Access Compliance Report

Public Rights-of-Way

(Curb Ramps)

Intersection ID: 48948	Main Street: BIRCHLEY_CR	Cross Street: DAVID_JENNINGS_AV	Location: SE
ADA ID: 3FFD8B411920	Ramp Type: Perp	Initial Pass/Fail: Pass	Overall Compliance: No
Severity Score: 5.25			
Codes/Mitigation Info/Possible Solution		Field Measurements/Component Compliance

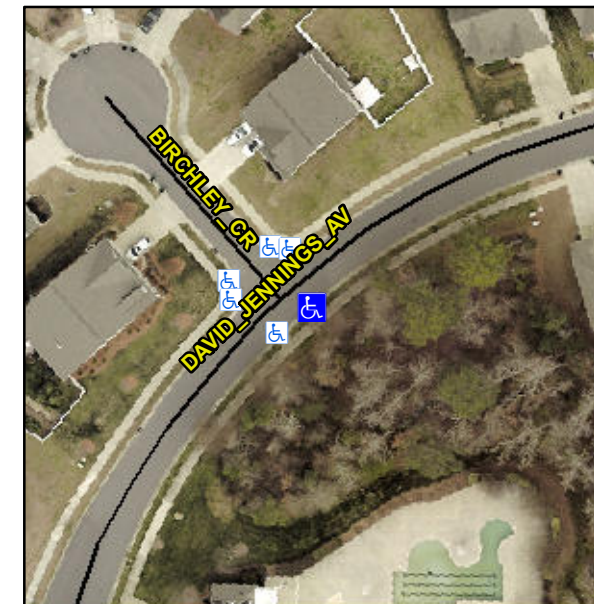
Not Found, R304.5.3, R304.5.4

Compliance	Description	Data	Compliance	Description	Data
N/A	Ramp Length (in)	47.5	Yes	Ramp Slope (%)	6.6
Yes	Ramp Width (in)	48.0	No	Ramp XSlope (%)	3.4
N/A	Flare Type LT	Sloped	N/A	Flare Type RT	N/A
N/A	Flare Slope LT (%)	0.9	N/A	Flare Slope RT (%)	6.1
N/A	Flare Traversable LT?	No	N/A	Flare Traversable RT?	No
Yes	Landing Length (in)	59.5	Yes	DWS Provided?	Yes
Yes	Landing Width (in)	48.0	Yes	DWS Contrast?	Yes
Yes	Landing Slope (%)	1.4	Yes	DWS Length (in)	24.5
Yes	Landing X Slope (%)	2.9	Yes	DWS Full Width?	Yes
N/A	Landing Curb? (Y/N)	No	Yes	DWS Offset (in)	0.0
N/A	Shared Landing?	No			
Yes	Gutter Ponding?	No	No	Gutter Slope (%)	14.9
Yes	Gutter Lip Ht (in)	0.0	Yes	Gutter X Slope (%)	2.3
N/A	Painted X Walk1?	No	N/A	Painted X Walk2?	N/A
	X Walk 1 Direction	To NE		X Walk 2 Direction	N/A
N/A	X Walk 1 Width (in)	N/A	N/A	X Walk 2 Width (in)	N/A
	X Walk 1 Slope (%)	3.5		X Walk 2 Slope (%)	N/A
	X Walk 1 X Slope (%)	3.1		X Walk 2 X Slope (%)	N/A

**Remove & Replace Entire Ramp.
Remove & Replace Gutter.**
